No. EL/1.3.10/3

Modification Sheet NO. RDSO/2017/EL/MS/ 0456 (Rev '0') Dated 09.01.2017

Modification in drawing of supporting ring to achieve adequate 'C' Clearance in MSU assembly of 6FRA-6068 TM in WAG9/ WAP7 class of locomotives.

CLW Drawing No. 1209-01.211-036 Alt '1'.

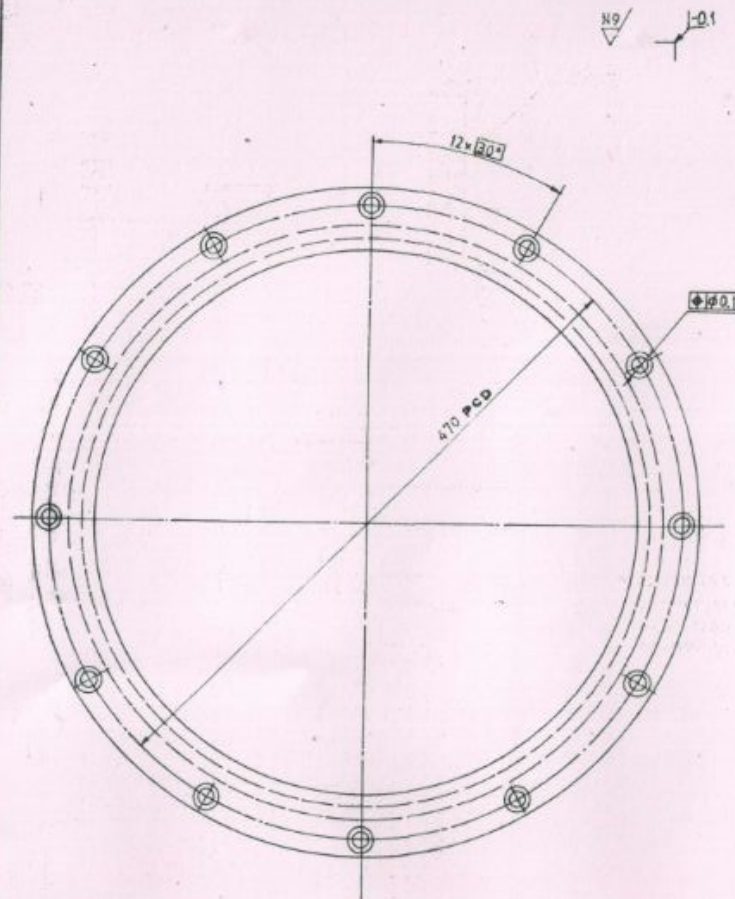
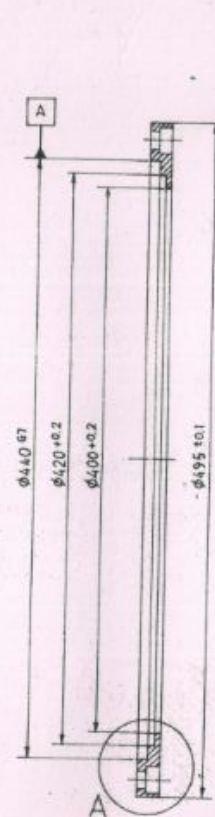
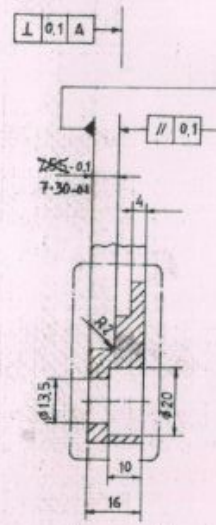
- 3.1.5. If C clearance is zero or negative, it indicates that supporting ring is not touching/pressing the outer racer of drive end (DE) bearing which is not desirable.
- 3.1.6. Supporting ring drawing No. 1209-01.211-036 Alt '0' specifies the depth of step available in supporting ring as $7.55_{-0.1} \text{ mm}$. It is observed that if depth of step is changed from existing $7.55_{-0.1} \text{ mm}$ to $7.30_{-0.1} \text{ mm}$, the calculated range of C clearance will be from 0.1 to 0.9 mm.

3.1.8. Accordingly, CLW had changed dimension $7.55_{-0.1}$ to $7.30_{-0.1}$ and issued drawing No. 1209-01.211-036 Alt.1 vide letter no. ELDD/3751/Pt. 62 dated 28.12.2016.

Supporting ring as per drawing No. 1209-01.211-036 Alt '0'.

4.2. During the new assembly of Suspension tube, Supporting ring as per Drawing No. 1209-01.211-036 Alt '1' to be used.

4.3. During the overhauling of Suspension tube assembly, if C clearance is less than 0.1 mm, existing supporting ring as per drawing No. 1209-01.211-036 Alt '0' to be replaced with Supporting ring as per Drawing No. 1209-01.211-036 Alt '1'.

4.4. After implementation of this modification sheet, range of C clearance will be from 0.1 to 0.9 mm.
